SUBJECT: Entergy Nuclear Operations, Inc.
Pilgrim Nuclear Power Station
Docket No. 50-293
License No. DPR-35

Pilgrim Relief Request PRR-21, Application of NRC Approved In-Service Inspection of Pilgrim Relief Request PRR-19, (Jet Pump Instrumentation Nozzle Weld RPV-N9A-1 Repair Plan) for Reactor Pressure Vessel N14-1, N14-NV, N15A/B-NV, and N16A/B-NV Nozzle Welds as a Contingency Repair Plan.

LETTER NUMBER: 2.11.015

PILGRIM RELIEF REQUEST (PPR)-19, JET PUMP INSTRUMENTATION NOZZLE WELD, RPV-N9A-1, REPAIR PLAN

Figure 1 Existing N9A Weld Configuration (1984 Repair)

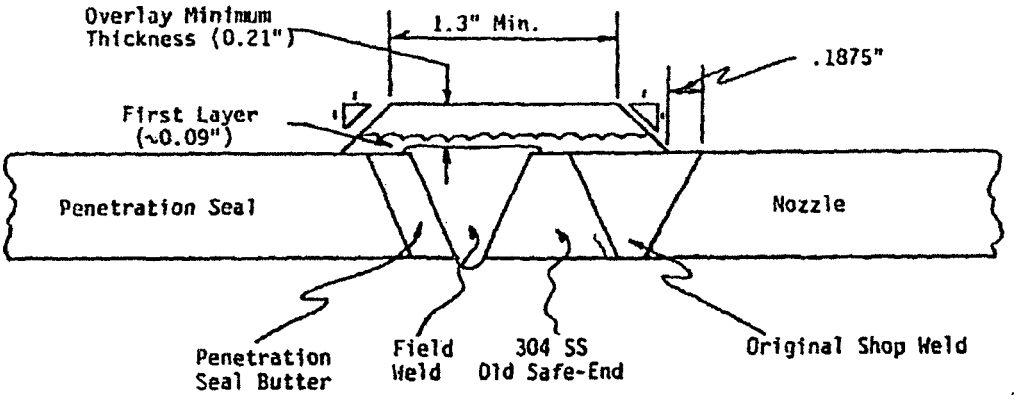
Supplement 11 as implemented by the Performance Demonstration Initiative (PDI). However, prior to performing the UT examination, PNPS determined that the subject WOL could not be appropriately examined due to its present configuration. See Table 1 and Figure 1 of Attachment 1 for additional details on the existing WOL configuration and materials. The Inservice Inspection (ISI) weld number for the subject WOL is RPV-N9A-1.

The N-9A nozzle WOL was originally installed in September 1984 to repair detected flaws discovered in the 304 stainless steel safe-end base material. The flaws (two) were located in the heat affected zone (HAZ) of the stainless steel safe end base material adjacent to the nozzle N-9A dissimilar metal weld (DMW). The WOL was designed to provide full structural reinforcement of the flawed material assuming a postulated 360° through-wall crack while maintaining ASME Code safety margins. The WOL was installed with Alloy 82 (ERNiCr-3) weld metal.

Figure 2 Proposed Weld Overlay

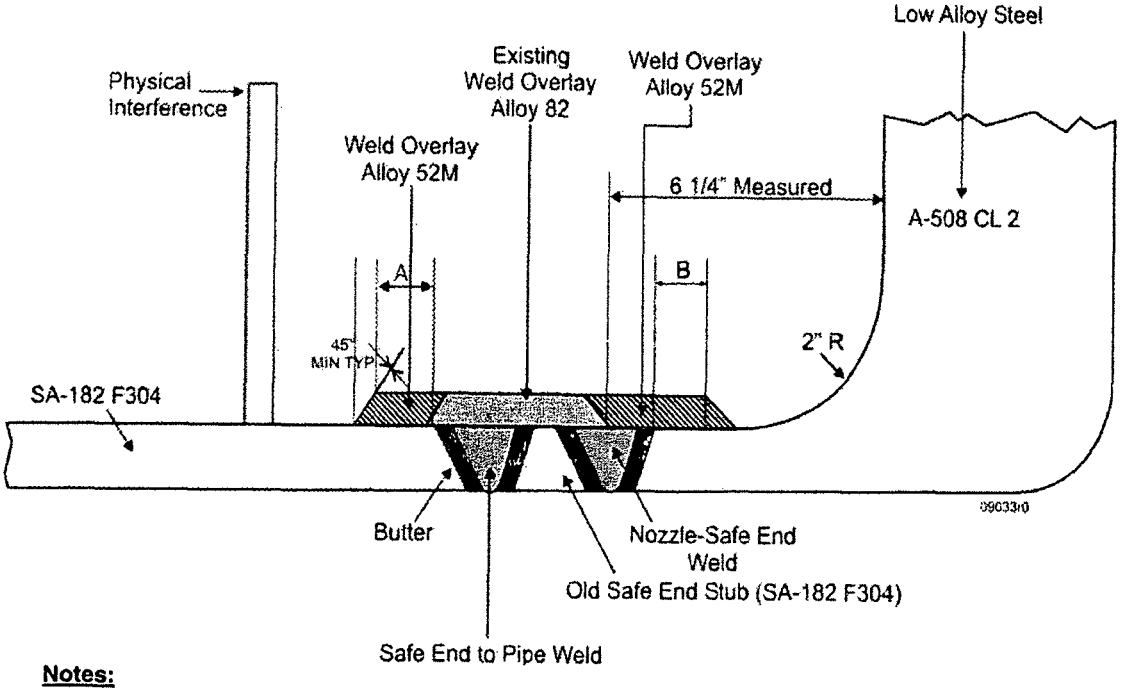
Entergy has initiated this request to propose an alternative to the ASME Section XI Code. PNPS intends to use Code Cases N-504-3 and N-638-1 to modify the existing WOL of the Jet Pump Instrumentation Nozzle N-9A (ISI weld RPV-9A-1). The modification will be performed using Alloy 52M (ERNiCrFe-7A) filler metal to facilitate performance of the required Appendix VIII, Supplement 11 UT examination. See Figure 2 of Attachment 1 for additional details.

4. Code Case N-504-3, paragraph (f)(1) and Appendix Q, paragraph Q-3000(b)(2) require that the end transition slope of the WOL "not exceed 45°". As an alternative, Entergy proposes to allow the end transition slope to exceed 45° provide the following two conditions are met:

- A physical restriction along the Jet Pump Instrument Penetration Seal Assembly prevents the WOL end transition slope from being 45° or less.

- The as-built configuration of the WOL is analyzed by Finite Element Analysis to demonstrate compliance with the applicable stress limits of the Construction Code.

0.22"min WOL Thickness A ≅ 0.6" Due to Physical Interference B ≅ 1" Minimum
